DEPARTMENT OF TRANSPORTATION**Federal Aviation Administration****14 CFR Part 36****[Docket No. FAA-2000-7958; Notice No. 00-11]****RIN 2120-AH10****Noise Certification Regulations for Helicopters****AGENCY:** Federal Aviation Administration (FAA), DOT.**ACTION:** Notice of Proposed Rulemaking (NPRM).

SUMMARY: The Federal Aviation Administration (FAA) is proposing changes to the noise certification regulations for helicopters. These proposed changes are based on a joint effort by the FAA, the European Joint Aviation Authorities (JAA), and Aviation Rulemaking Advisory Committee (ARAC), to harmonize the U.S. noise certification regulations and the European Joint Aviation Requirements (JAR) for helicopters. These proposed changes would provide nearly uniform noise certification standards for helicopters certificated in the United States, the JAA countries, and other countries that have adopted as their national regulation either the United States regulations, the JAA regulations, or the International Civil Aviation Organization (ICAO) standards. The harmonization of the noise certification standards would simplify airworthiness approvals for import and export purposes.

Figure H1.
Comparison of Measured and Reference Takeoff Profiles

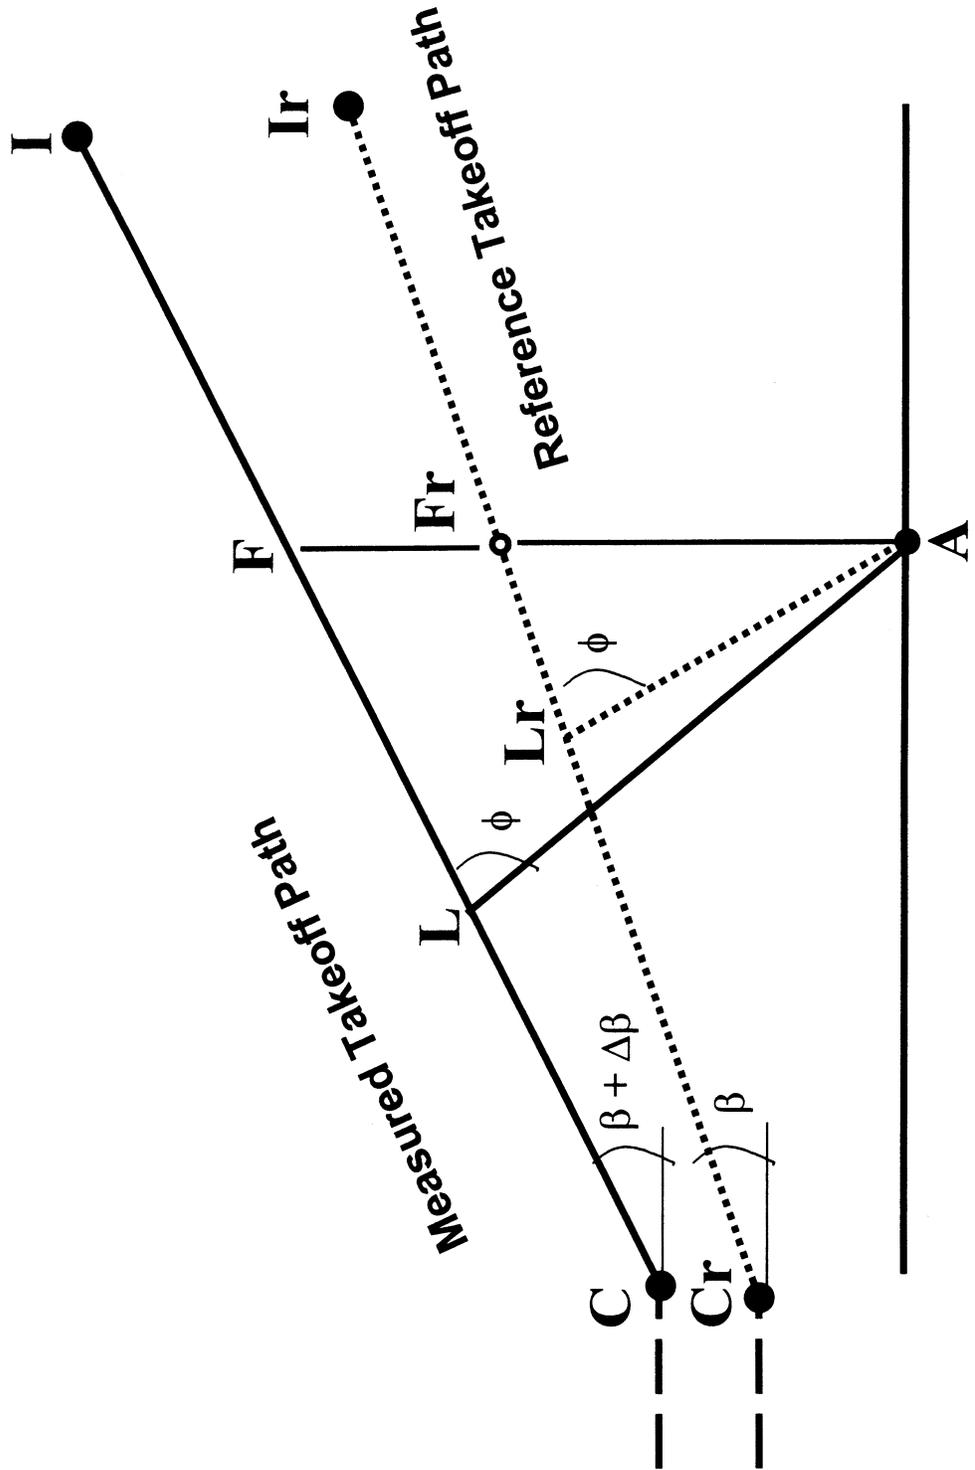
Proposed revision to Figure H1 deletes the designation of Positions Tr since the minimal distance designation is no longer needed and includes the height above measurement point in metric units; see the text of proposed section H36.205(b)(3) regarding the takeoff condition.

In proposed Figures H1, H2, and H3 the titles of the figures are changed to reflect the language of this proposal. The word "reference" would replace the word "corrected" in each title.

**Figure H3.
Comparison of Measured and Reference Approach Profiles**

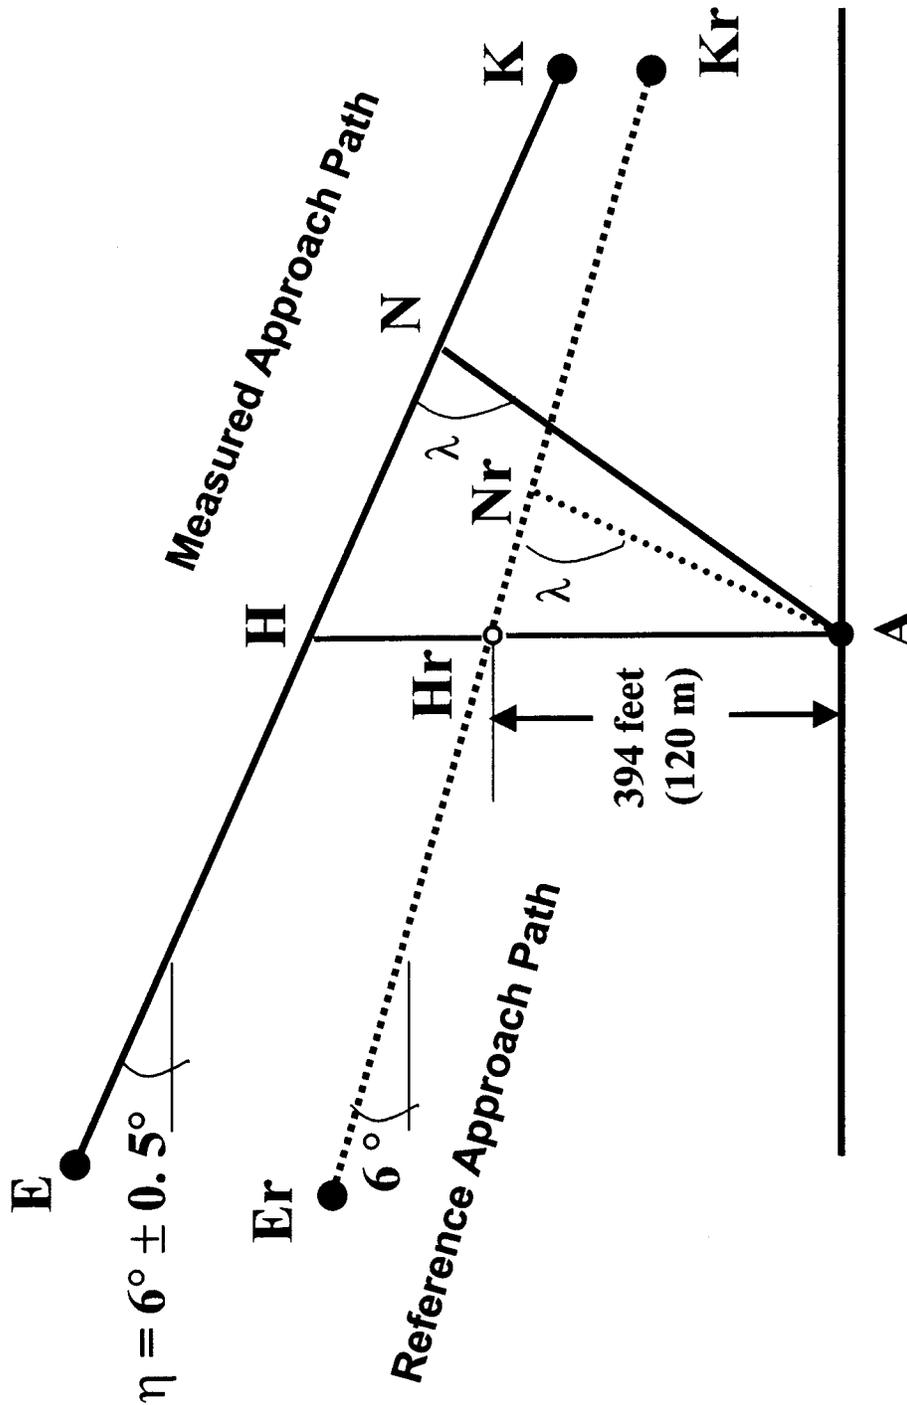
Proposed revision to Figure H3 deletes the designations of Positions S and Sr since the minimal distance designation is no longer needed and includes the height above measurement point in metric units; see the text of section H36.205(d)(3) regarding the approach condition.
